**RE: OBJECTION TO SSD-77829461**

Thank you for the opportunity to comment on State Significant Development Application (SSD-77829461) for demolition of existing buildings and construction of a residential apartment development with 111 apartments, including 29 affordable housing apartments, with communal open space, associated landscaping and parking for 150 cars in 3 basement levels and lot consolidation at No. 2 – 4 Larkin Street and 1 – 5 Pockley Avenue, Roseville.

### **Ku-ring-gai Council's objection to SSD-77829461 at No. 2 – 4 Larkin Street and 1 – 5 Pockley Avenue, Roseville.**

**Figure 1: Building Sections – A, Sheet No. DA-AR-A-32-101, Revision A, prepared by Woods Bagot, dated 14/04/2025.**

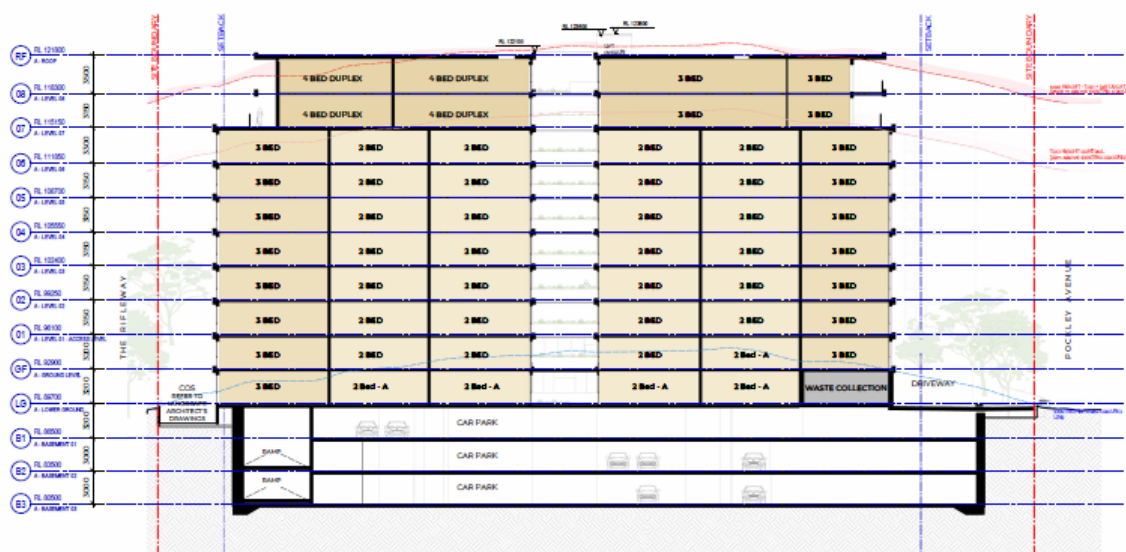
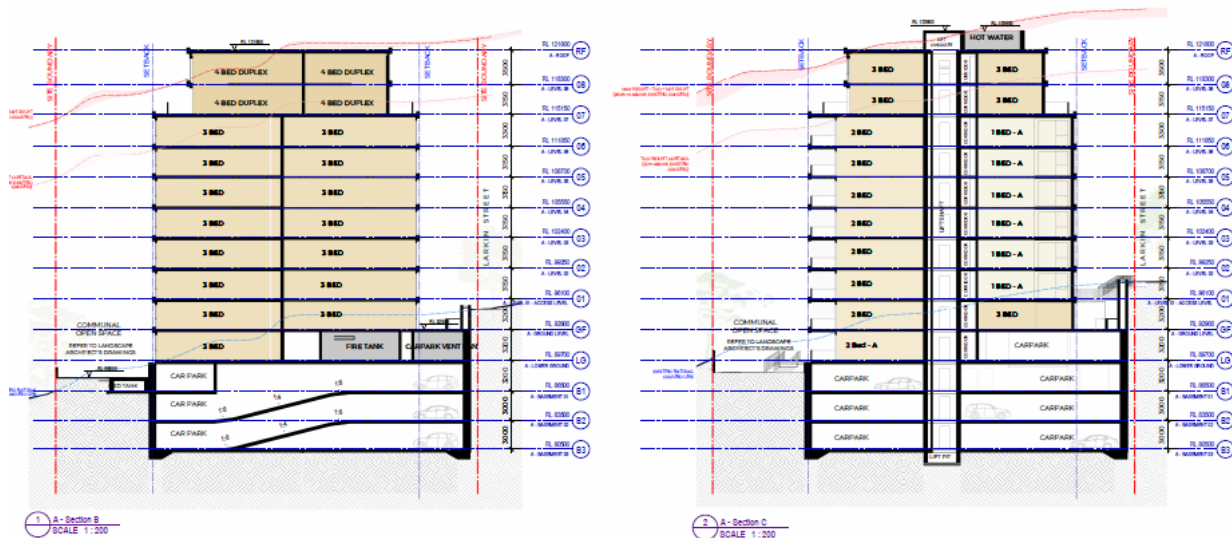
The proposal seeks a maximum building height of 30.22m, measured to top of the rooftop plant which exceeds the maximum building height control by 2.17m, equating to a variation of 7.7%.

Other building elements on the upper level of the proposed building, also exceed the maximum building height development standard as shown in Figures 1 and 2 below.

Upon review of the proposal, Council does not consider the Clause 4.6 variation request to be well founded and objects to the variation of the building height development standard for reasons as follows:

- *The extent of the variation contributes to excessive building bulk and scale beyond the building envelopes envisaged for residential flat buildings, including compliant setbacks, articulation and built form. The proposal will detract from the desired future character of the streetscape, significance of heritage items and the amenity of surrounding residents.*

- *The extent of the variation at the upper level of the proposed building will be clearly visible from surrounding streets and the locality contributing to excessive building bulk and scale that is incompatible with the character of the locality.*

- *Insufficient overshadowing information has been submitted to clearly identify the full extent of additional overshadowing cast by building elements that exceeds the building height development standards. It is likely that there will be additional overshadowing of the potential future development site at 7-11 Pockley Avenue and foreseeably the 2-16 Pockley Avenue (approval for which is being sought concurrently by the same applicant). View loss will also certainly be affected but in terms of amenity impacts the additional overshadowing presents a bigger concern. The overshadowing and view loss impacts that result from a fully compliant scheme is not provided to demonstrate whether or not the additional impacts of the height variation are in fact negligible.*

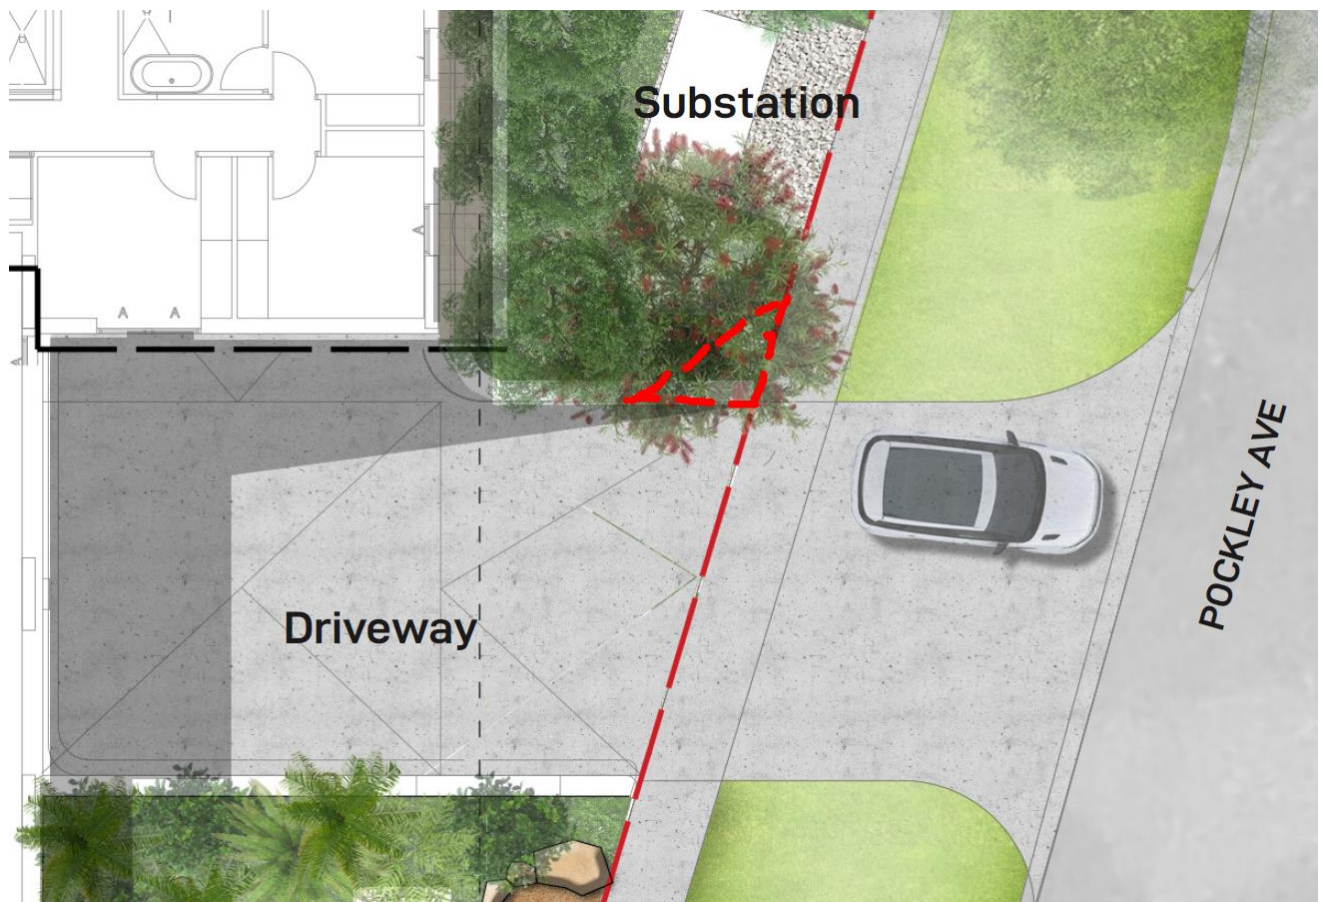
A 7.2m wide access point at the property boundary is proposed (which is acceptable). At the edge of bitumen alignment, the gutter crossing width splays out to approximately 11.3m, presumably to facilitate the swept paths of the service vehicle entering and leaving the site.

It is unclear whether the 2m x 2.5m sight triangle as per AS2890.1 (shown in red below) has been provided, but this could be conditioned:

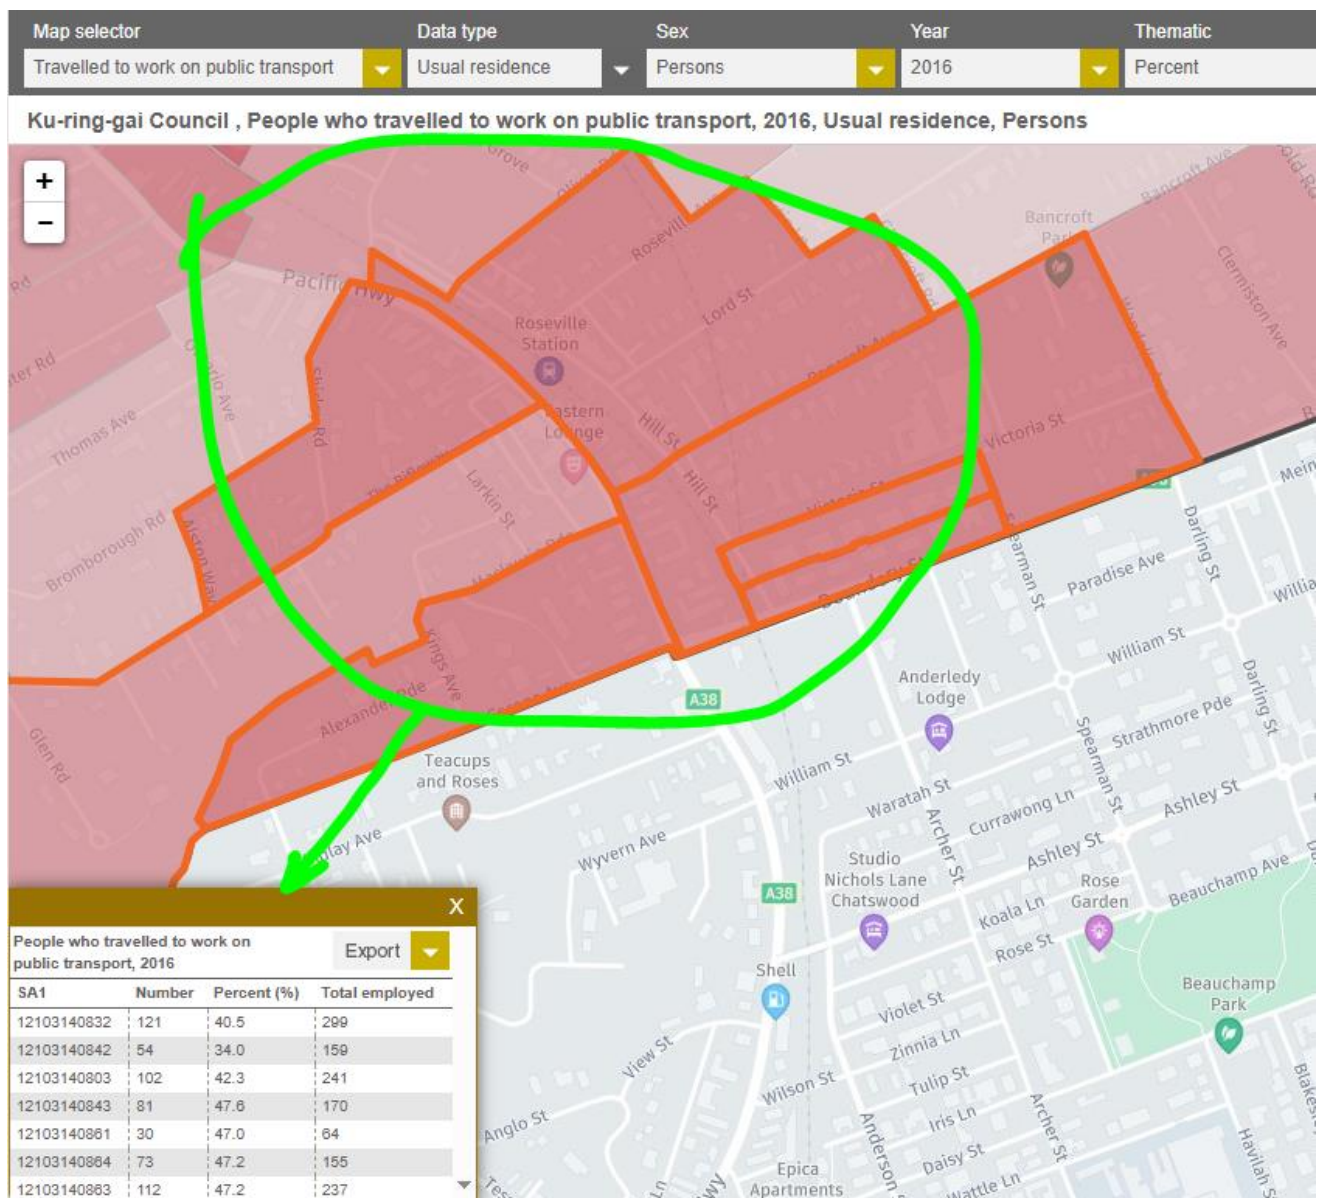
This section notes that there are existing car share vehicles by one car share provider in the area, with the closest being in Hill Street, near Victoria Street (approx. 10 minutes walk from the site) and Westbourne Road Lindfield (approx. 10 minutes walk), but these are unlikely to be convenient locations for residents of this development. Also, these are not a car share vehicles in a fixed/allocated space, but free-floating vehicles, and their longevity at these locations cannot be confirmed. The proposal is making provision for on-site car share anyway, therefore references to these car share vehicles should be removed from this section and the Transport Access Guide in

1. References to existing car share vehicles should be removed from Section 3.2 (Car Share) of the Green Travel Plan, as well as from the Transport Access Guide in Appendix A.
